Response to ISH5 Action Point 36 on Behalf of the
**Neighbours and Users of
Queen Elizabeth Park**

Interested Party reference no: **20022545**

'Submit report regarding potential trenchless solutions in QEP and how the effect of stringing out could be minimised'

2. Proposed Alternative HDD Launch Area in QEP

Plan extract showing proposed HDD launch area (full drawings in section 4)

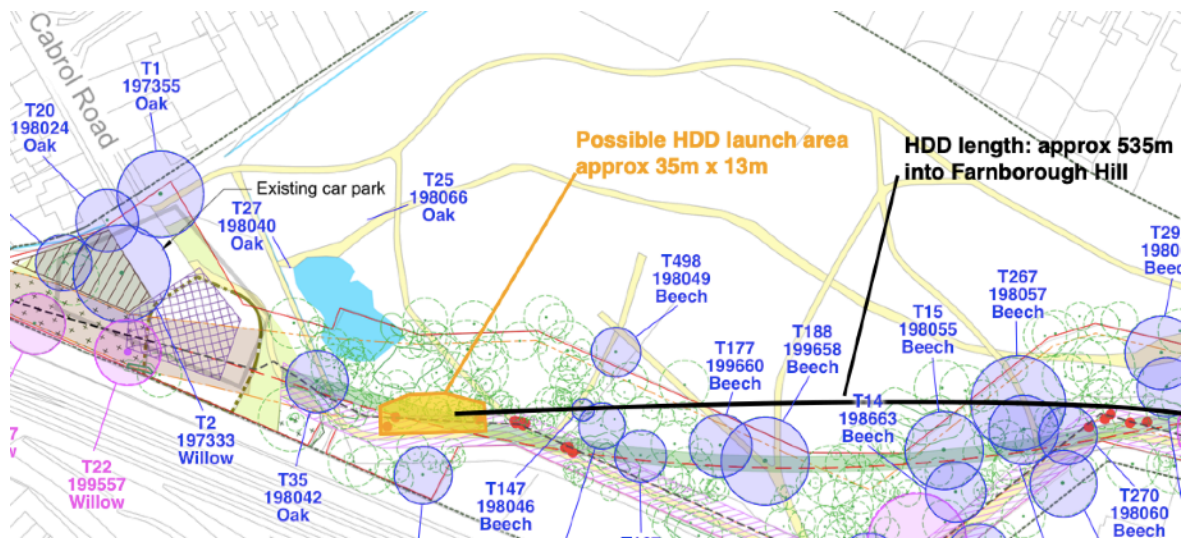
It would seem that using an HDD launch area further within the park could allow HDD to be used. Our proposed HDD area is adjacent to the southern path, approximately 50 metres from the play area.

1. The proposed HDD area is currently occupied mainly by birch trees and brambles. It does not contain any Notable or Veteran Tree RPAs.
2. The proposed HDD area is completely within the current Order Limits.

3. Three trees in this area are currently identified for removal by Esso, but additional trees could also be cleared to create the necessary working area.

4. Dimensions are approximately 35 x 13 metres.
5. More width might be available depending on suitable care being taken in RPAs and whether the path is used as part of the compound.

6. Access to the site from the Cabrol Road compound area is via the path, with at least 5 metres width available if brambles and rhododendron are cleared. Suitable protection of T35's RPA would be required.

7. The bore can be designed with straight alignment at each end so that the curvature of the alignment is in the vertical plane only at the ends and in the horizontal plane only in the centre section where the bore is level.

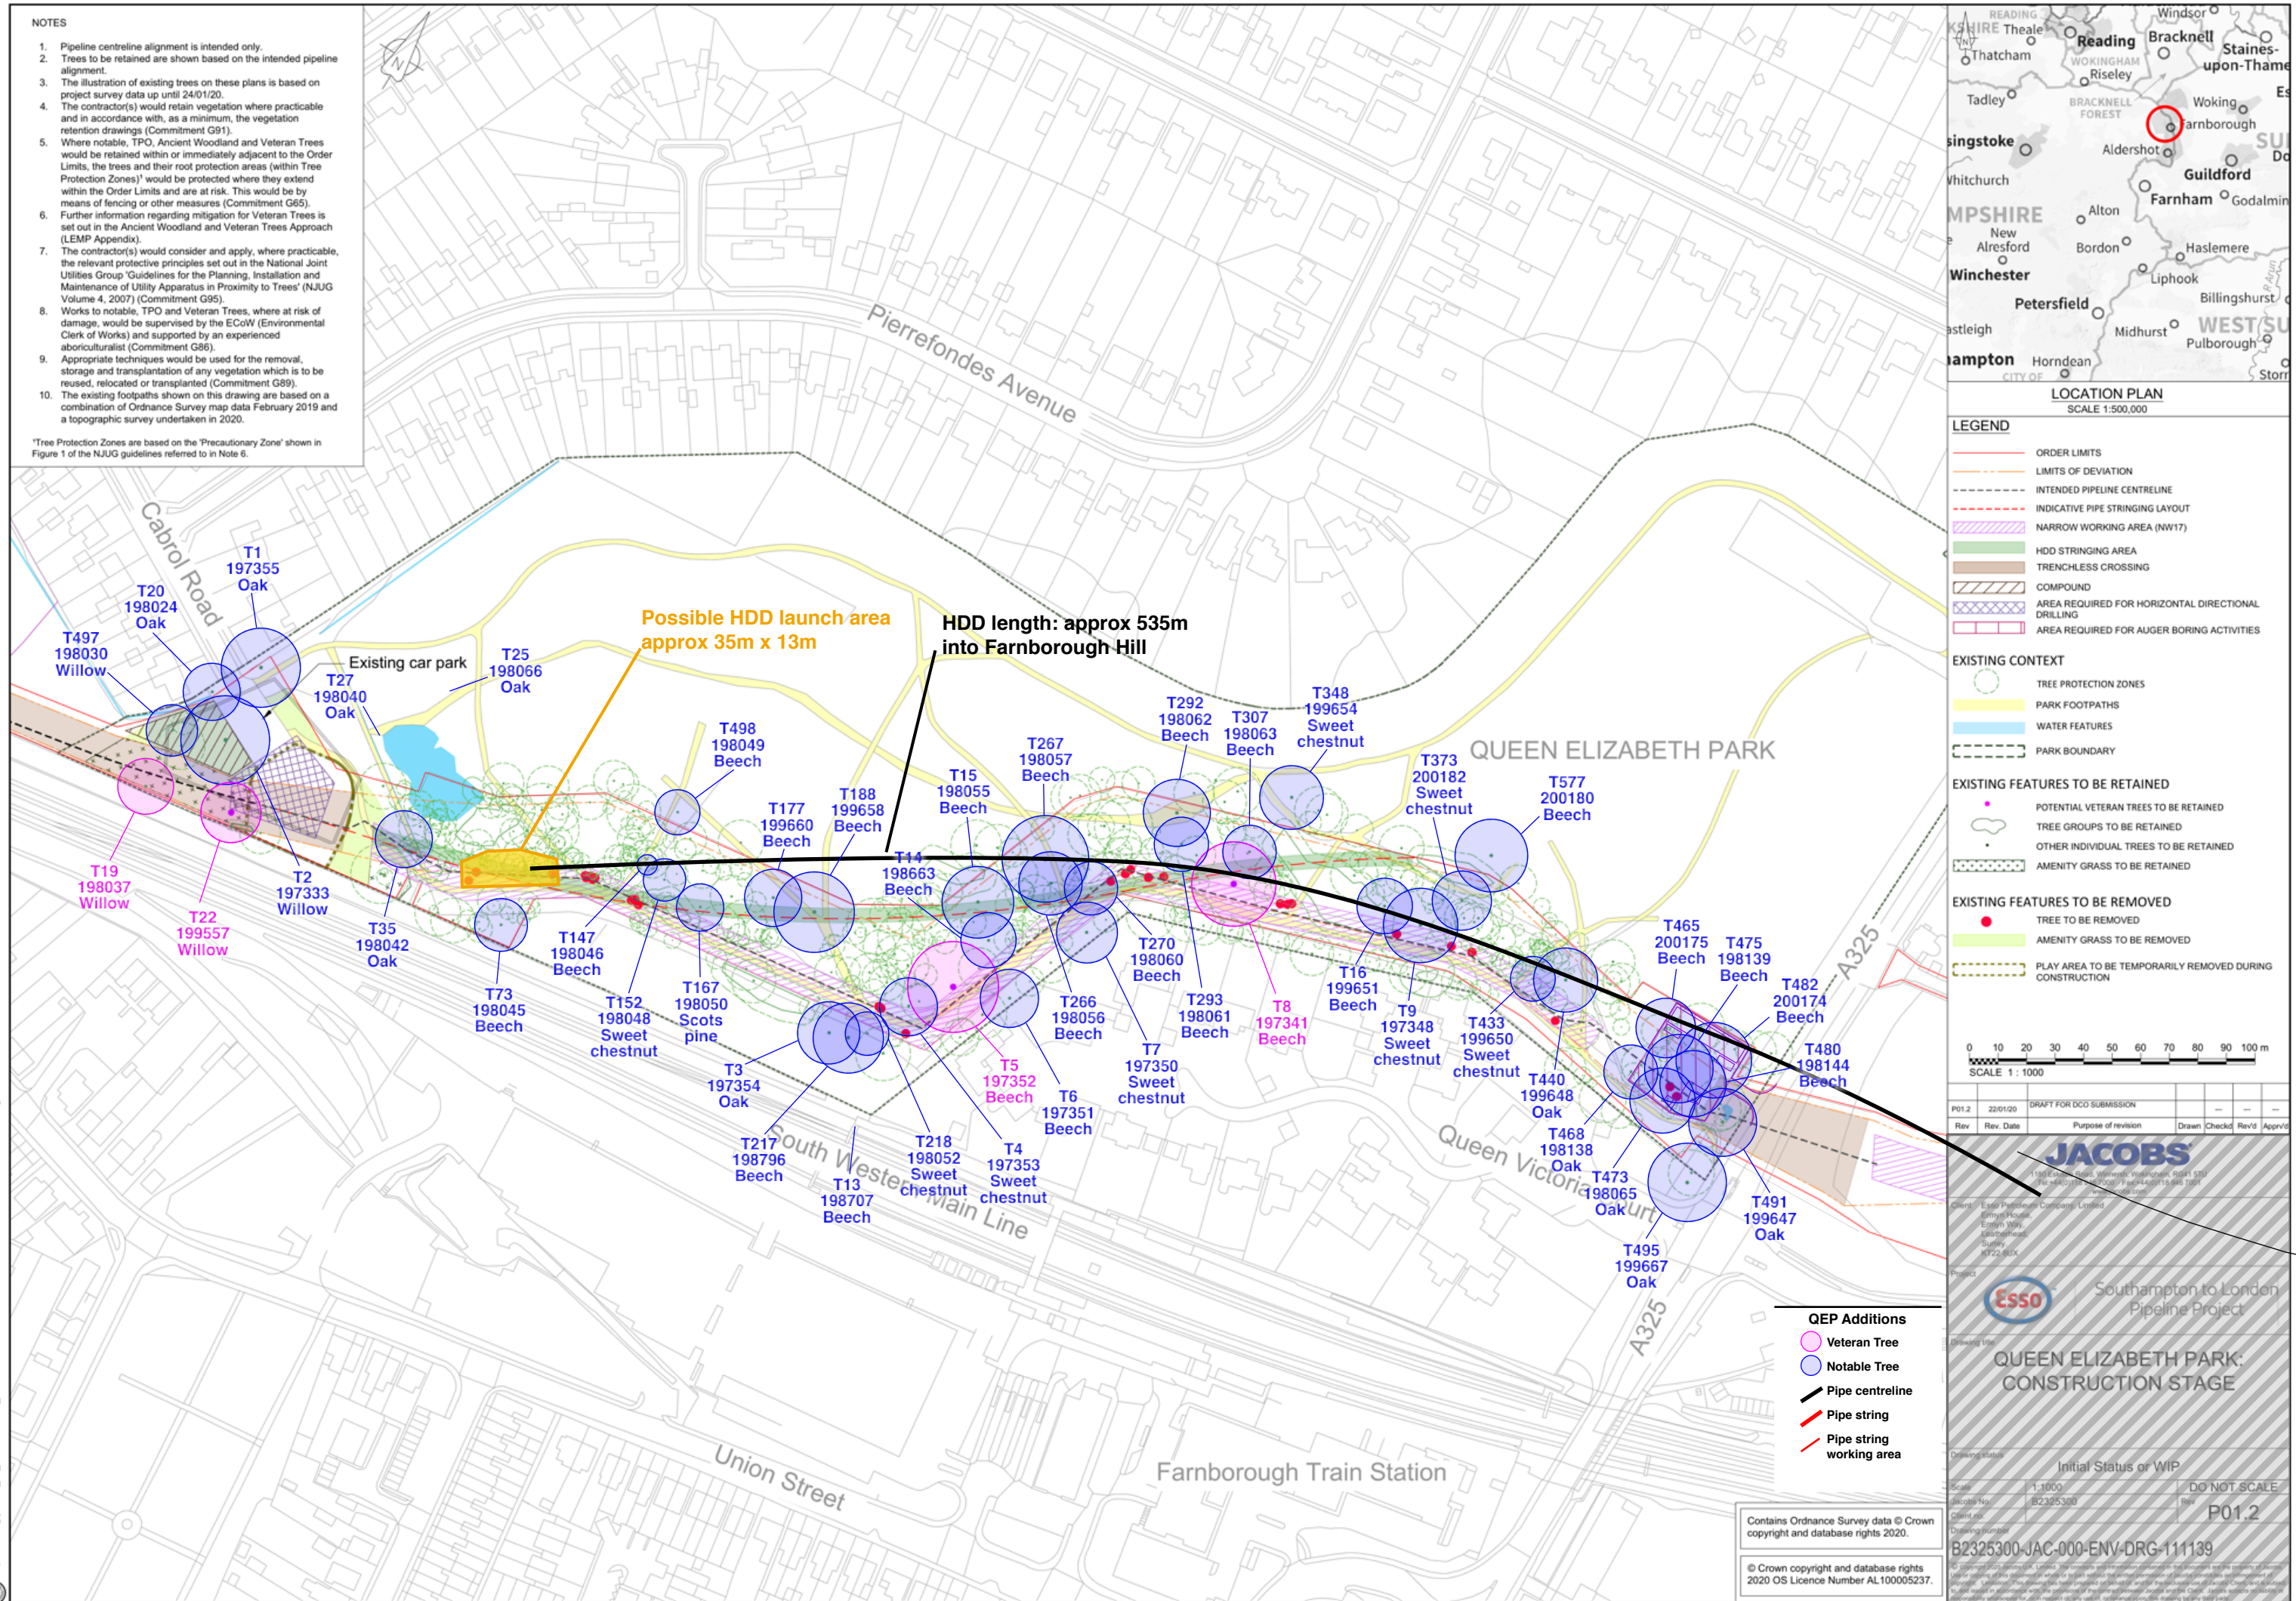
Although this is not our main proposal, there is yet another option for using HDD to cross the park. Two straight bores could be used if the pipeline is routed via the glade.

This reduces the length of the bore from the park to Farnborough Hill to approximately 480 metres.

The shorter run would be bored from the Cabrol Road compound with a stringing area to the north-east of the glade.

Access to the glade is more complex, indicated by the curved red line, however a suitable path between the trees could be found.
